BYRON SHIRE COUNCIL
DOC NO:
REC'D: - 9 APR 2021
FILE NO: A84076
ASSIGNED: C. Smith
Federal, NSW 2480

A new DA10.2019.650.2 was lodged March 25th 2021 to change DA10.2019.650.1 for 103 Kings, Rd. Federal, passed April 2020. Re new entry, new drive & New Dual occ. Now at lock up stage. Although the new DA was only lodged March 25th 2021, with public exhibition ending 13th April, Council Plan is to address new DA, in the May Council planning meeting. We have been told we will be invited & due to the impact to our home we hope Councillors will be able to attend.

Original DA with approved mitigation measures.

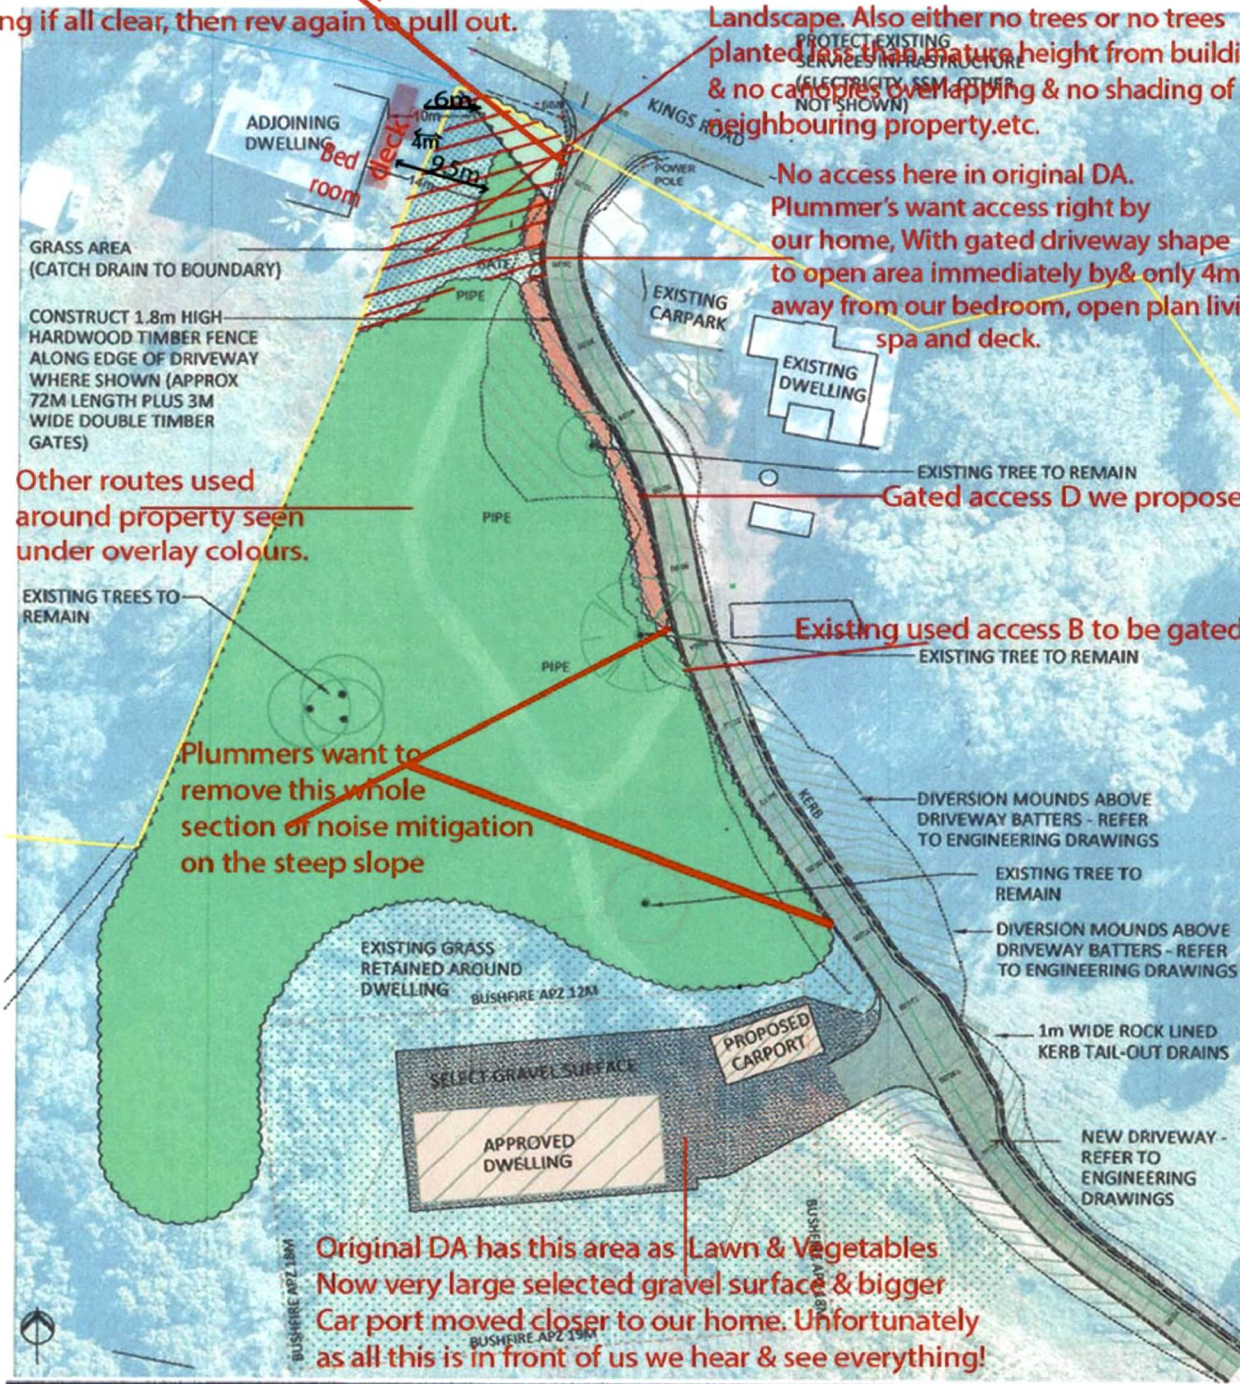
Plummers want to loose all noise mitigation at entry. Where vehicles rev. to hold position whilst looking if all clear, then rev again to pull out.

This area on original DA is 1 area. It should remain as 1 area. On original DA called formal Landscape. Also either no trees or no trees planted less than mature height from buildings & no canopies overlapping & no shading of neighbouring property.etc.

Mr. & Mrs Plummer's amendment, with our comments in Red.

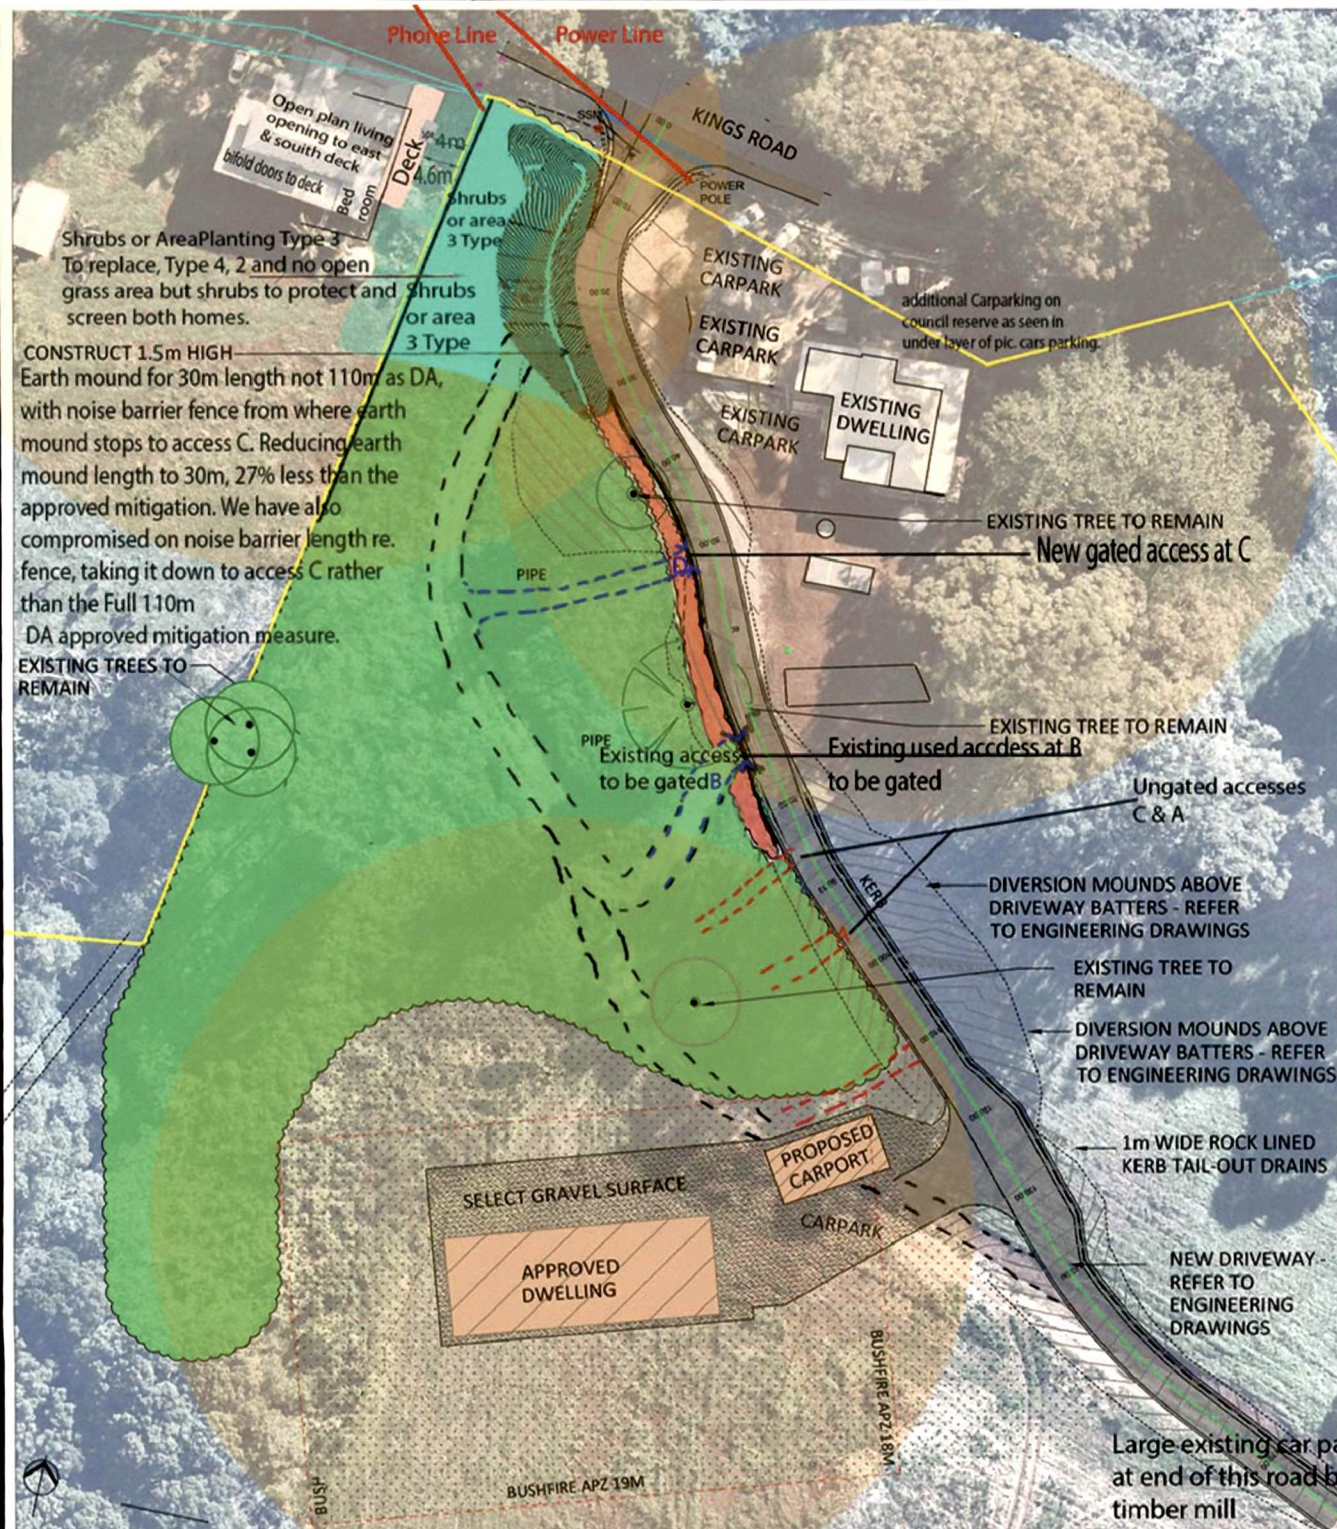
Original DA has this area as Lawn & Vegetables Now very large selected gravel surface & bigger Car port moved closer to our home. Unfortunately as all this is in front of us we hear & see everything!

Earth mound at top of driveway, they can drive over it with tractors or mowers, but stops general usage by our bedroom window etc.

Compromise Option 2

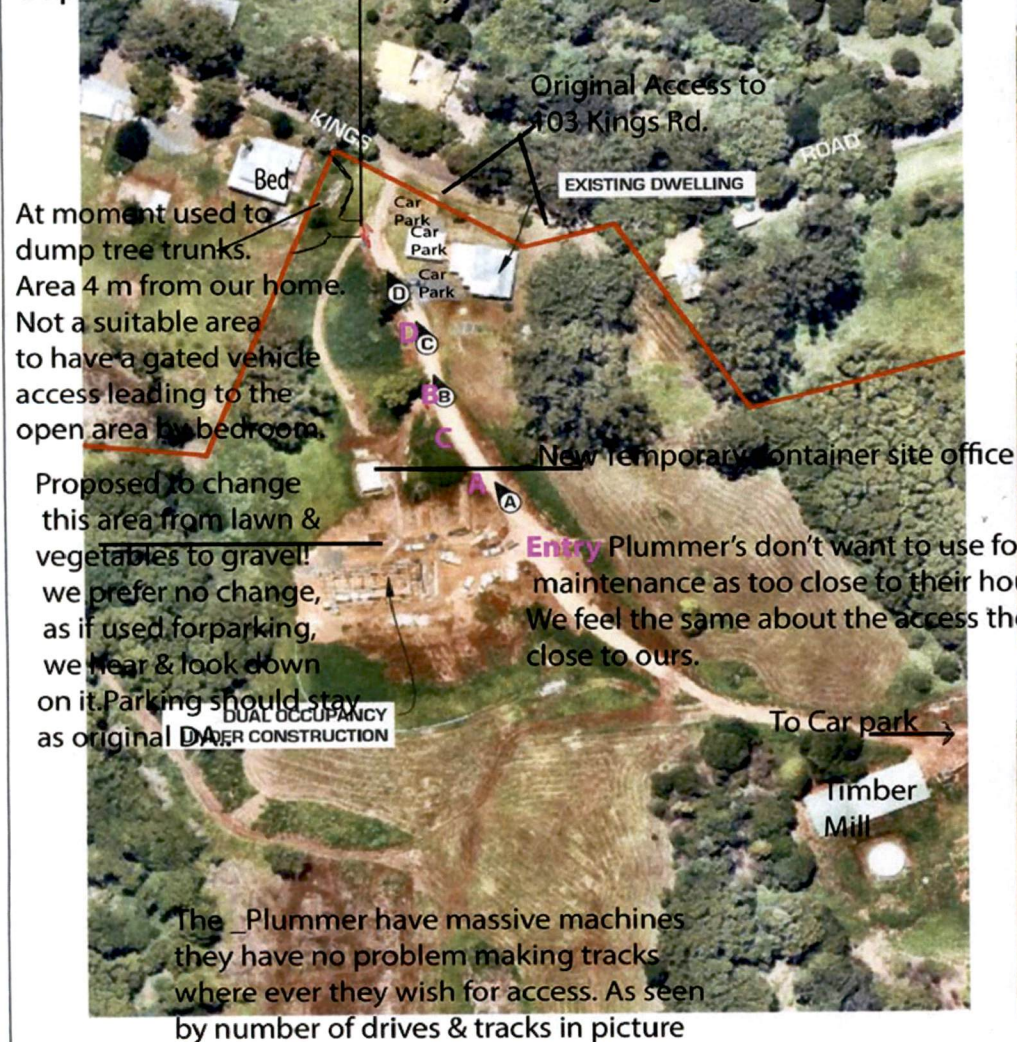
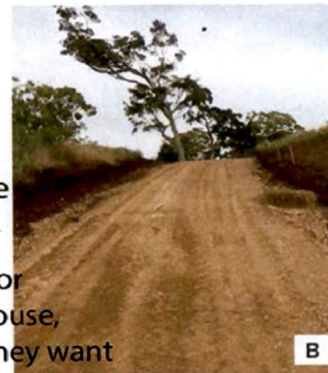
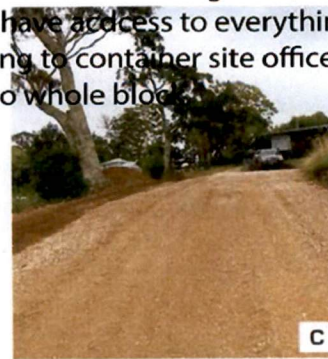
Plummers have new cross over at top, granted after DA, (moved 20m closer to our home than previous owners X over.) to new steep driveway. Plummer's have done earth work/levelling by our eastern deck, prior to this application, & caused damage to our Spa as they brought heavy machines very close, our house shook. We cannot allow vehicles so close to home & outside our bedroom window. Landscapes should be designed to avoid these impacts. Government guidelines are vehicles should not pass close to bedrooms & there should be screening between noise source & homes. (Docs attached.) It is unreasonable for Plummers to insist on even closer access points to our home. Mowing & maintenance easily done via several other access points either existing or new. (D,B,C,A) At the moment they use access B. We are sure councillors & council will understand the obvious reasons why vehicles should not be facilitated to pass so close to a bedroom & existing home. Plummers bring vehicles very close, they have also dumped a huge pile of tree trunks on boundary. Also park with head lights pointing into our bedroom. If they want to do a 30m length of 1.5m high,

COMPROMISE 1 as gives all Plummers want, access & use & protects our property. The earth mound reduced from 110m long to 30m long (1:3 ratio). Tractors & mowers can pass over this for maintenance & tenants can wander over, rather than a fence that blocks area. Then a choice of gated accesses D & B or ungated C & A there is another existing by their new house, which understandably they do not want as vehicle access close to house. Mound to be 1.5m high, noise barrier fence to be 1.8m (Should be 2m for noise mitigation.)

- Planting Type 5- Shrubs or alternatively, Planting Type 3 for screening. to comply with APZ & DCP 2014 Ch B9 & good practise.
- Planting Type 1 - Existing grass (Already planted with some shrubs in 2020)

- Planting Type 2 - Entry Planting No tree should be planted closer than its mature height to a home 12m high limit by road side, not 3x22m Trees as plan. 57m² (See Plant Schedule)

- Timber fence - 1.8m high hardwood should be 2m high, lapped, no gaps between ground & fence, for noise mitigation standards. pipes under for sm. wild life & drainage.

Type 4 has over 1,450 Trees 30+m, 20+m 10+m More trees under 10m, not enough space, breaching DCP 2014 Ch. B9 & good practise, DPI house buffer zones, these are plantation species. Ranamok do carbon offset. Paid per Tree? Density = \$? Density too great for Trees to thrive. Where is their canopy design?

1.5 m Earth mound substantial reduction in length from 110m to 30m 27% of the Earth/Fill of earth mound, approved as necessary mitigation in DA planned by Chris Larkin & Karina of NDC (Newton Denny Chappel) is the most effective mitigation, It should not be completely abandoned as a condition of DA approval, but adjusted. The 1:3 ratio on sides allows mowers & tractors to pass over as pointed out by Greg Smith. Enjoyment of the area for residents is not fenced off. After 30m of earth mound for rest of mitigation 1.8 m (For noise mitigation 2m recommended & better,) lapped & capped. No gaps under as this allows noise, reverberation, fumes & dust through. For drainage & small animals, short lengths of pipe buried at intervals pointing down slope. The owners do not want an access by their new house, we feel the same. Unfortunately on her diagram Karina has ignored the 4.6m deck & spa, the actual perimeter of our home. Our bedroom window & open plan living, deck & Spa, are 4.1m away from boundary & face the access the Pummer's want by our home, with the gated driveway shape to open area outside our bedroom, Karina wants gravel or grass, we propose shrubs or area 3 planting. Karina on a site visit with planner's Greg Smith & Chris Larkin said they wanted the open area outside our bedroom window as parking for open days, parties etc: it is presented to yourselves as a gated access, near our home, that has a driveway shape, that links to the unapproved driveway they used prior to Dual Occ. DA or to the open area by our bedroom. I asked Greg Smith, if what they want is approved & they used it for Car Parking as Karina said, what would planning do? I was told it would not be planning, but a compliance issue. Compliance could do nothing as no provision breached. Defacto loss of bedroom & open plan living, deck & Spa. Our home becomes unviable. We have already been massively impacted. The access for existing house, was 20m to East away, with no steep driveway to a new house which is very close & very noisy due to steepness. Unfortunately we see & hear everything. Please do not make our family home unviable. Options: Access D, B, Cor A. Keep Vehicle access & movement, away from bedrooms as per Gov. guideline.

Another compromise, no earth mound, the most effective mitigation. We offer instead to accept the Plummers fence, that they offer not even to noise mitigation standard, 1.8m high. But must be with no gaps, under as this is known to compromise mitigation further instead, small pipes at intervals buried under, facing down slope for drainage & sm. animal movement.

Plummer's no longer want to do fence here another compromise.

Mitigation need
to be to entry.

Compromise on length of mitigation
mitigation should be down to the
approach to the new house as DA

Planting type (5) as original DA Entry Planting. As per
original DA, but either no Trees or No overlapping
canopies. No Tree planted less than its mature height
from an existing structure, No shading of existing
structures, no canopies causing leaf fall on roof & gutters,
affecting water quality. In line with DCP2014 Ch. B9 &
good practise, & Appendix 5 bush fire provisions.

PLAN A: VIEW FROM DRIVEWAY

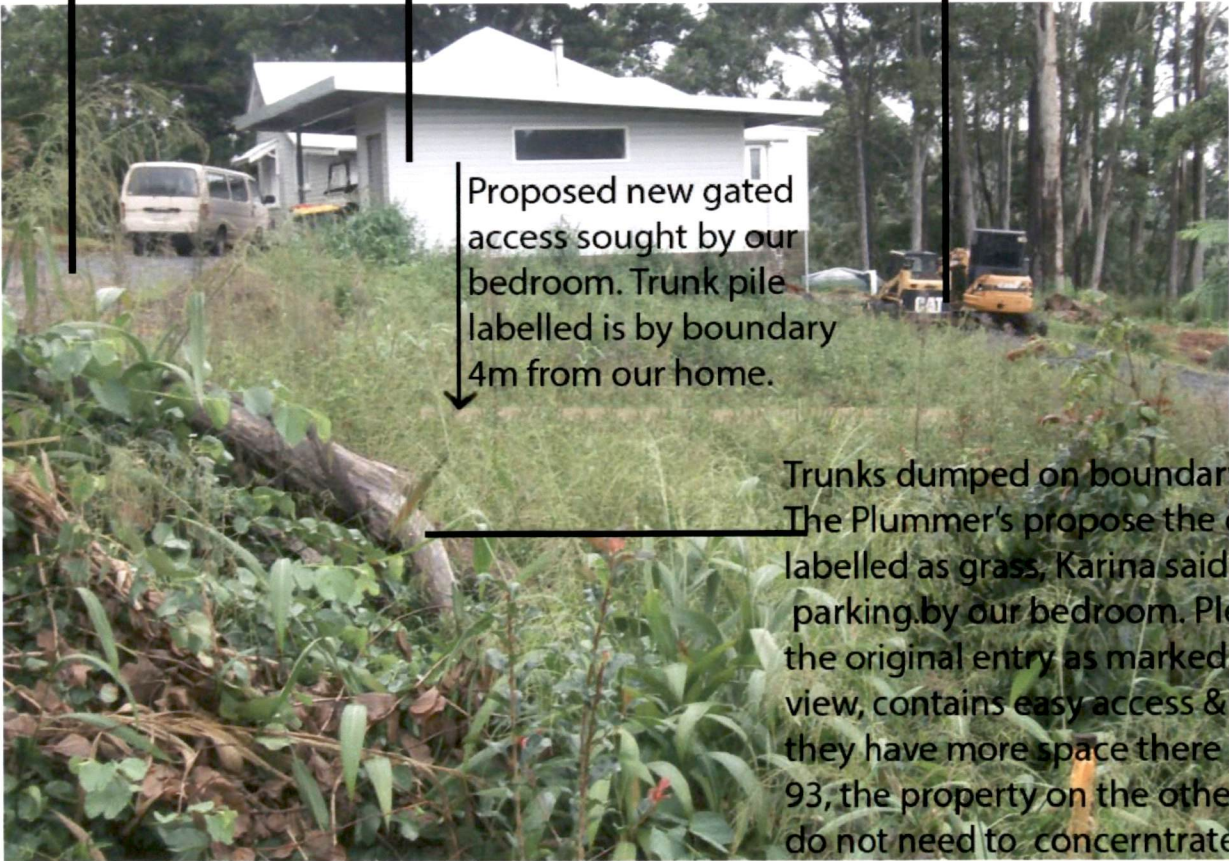
Choice of Easy access D, B, C & A (our compromise)

several choices that do not affect existing homes and do not steer
vehicles closer to bedrooms decks & living areas. This allows access
to all of western area for maintenance and use. But does not focus
vehicles deliberately towards our home, bedroom, living & decks.
The new access at top already granted, after DA, moved access 20m
towards our home, (than previous owner's access) & the steep
driveway beyond, has already had a heavy detrimental
environmental impact. The area shaded is even closer to our
home. Plummers have already got the new access at top via new
X over, already granted & with additional options DBC&A access to
whole area. They use mostly B as you can see from this access not
being overgrown on aerial views. If they want still more they should
do the earth mound at top, 30m, compromise 1, as mowers & tractors

Access, the Plummers want by our house, would link to the 1st driveway the Plummer's made. This would Bi Pass the mitigation bringing Noise, reverberation, dust fumes even closer to our home.

Whereas if **D** is used, still in the upper section of driveway, the vehicles pass behind the mitigation, where they are most close to our home. This is reasonable, as Plummers still have access to everything for maintenance etc. as you can see they area already using **access B**, leading to container site office, **B** & past container to 1st driveway in front of mitigation, giving easy access to whole block.

Colour used for access points we offered in Compromise 1 & 2 so you can relate them to this picture. Please note Karinas ABCD denote points on driveway, not accesses our points: **DBC & A** relate to accesses either already in use at **B** or offered as alternatives to the one the Plummer's want by our Bedroom.

Distance of The perimeter of our home to boundary

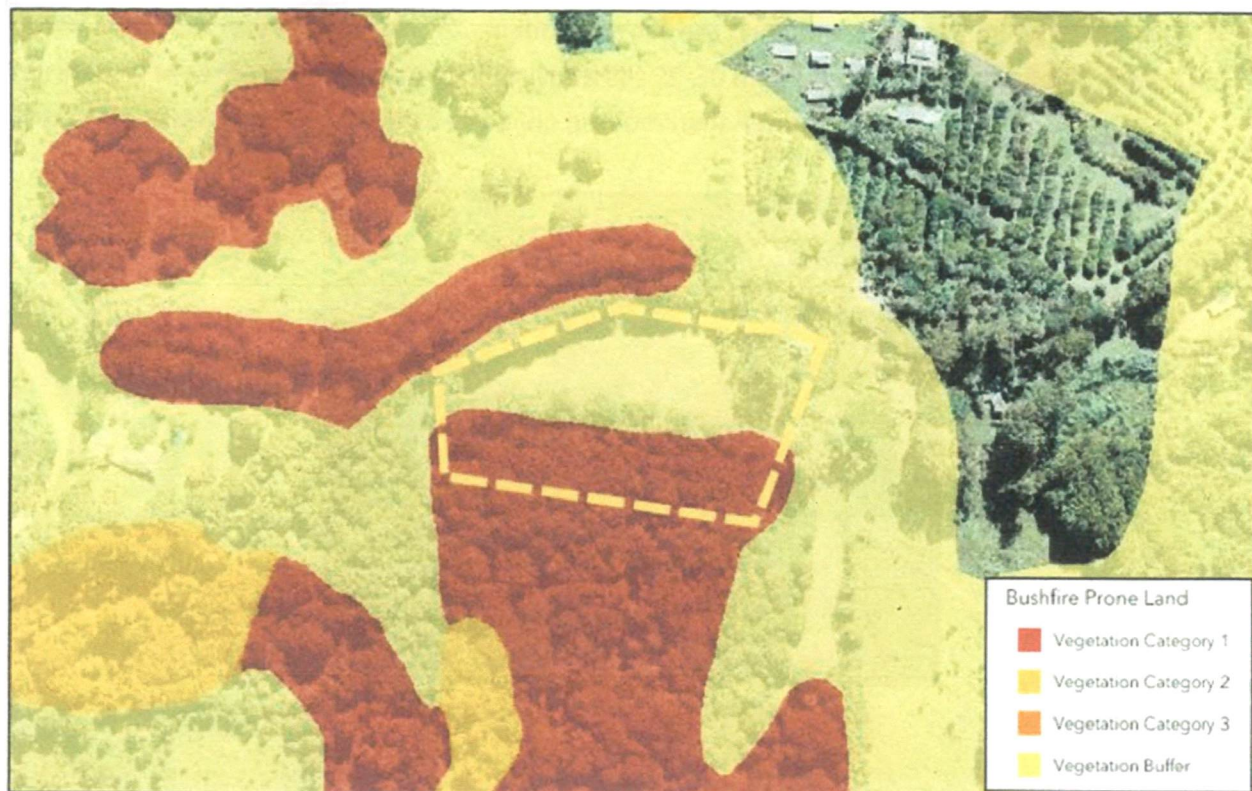
Striped area, is labelled as grass, in amendment, With driveway shape leading to it.

Karina sais for use as Parking

The Deck is to be re roofed as it needed to be replaced, since it is the only roof suitable for solar panels. We have been waiting until the mitigation is in place, as we don't want the new solar panels to be plastered with all the dust that is coming from the Plummer's new driveway, which is not sealed yet. We have been putting up with the Noise, reverberation, dust, fumes & visual nuance for a year. It has held up the re roofing & the installation of the solar panels.

Proximity of what the Plummers are Trying to squeeze into a small area. Area 2 on original DA, that is meant to be formal entry planting & along driveway, Area 2 should not be changed in this amendment..
